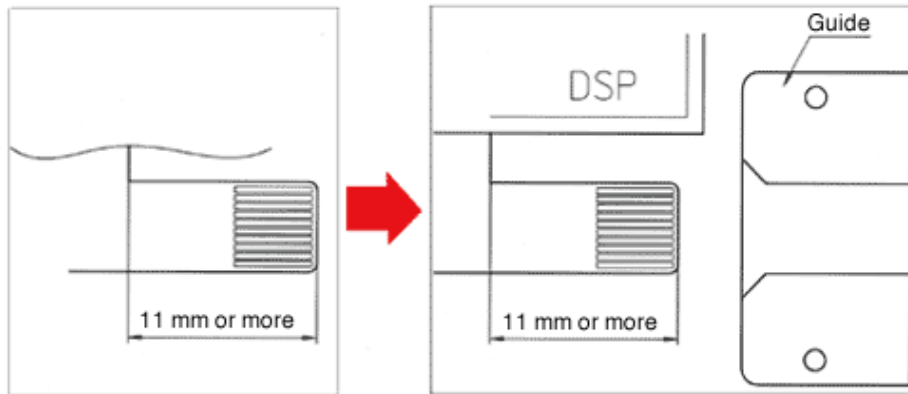
- Please submit a range of diagrams showing the configuration and conditions about 20 mm from the tip of the flex and indicating general peripheral conditions near the flex.

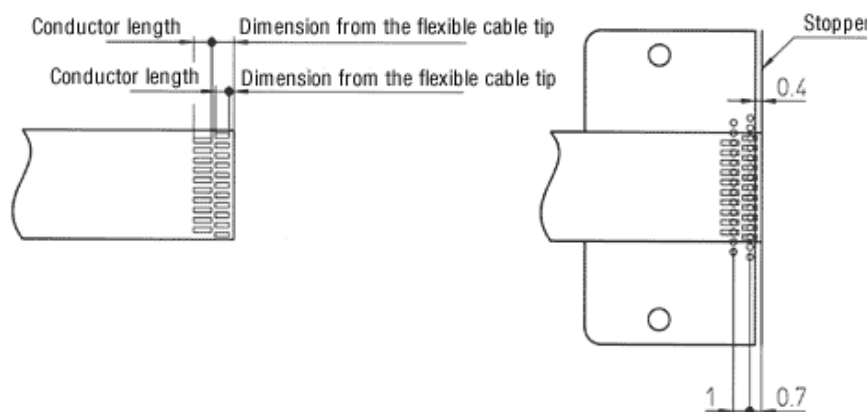
Fabrication OK for flex part

But in fact, a product component is located near the flex. Fabrication in CCJF series

————— From our product line, we will propose an effective product. —————
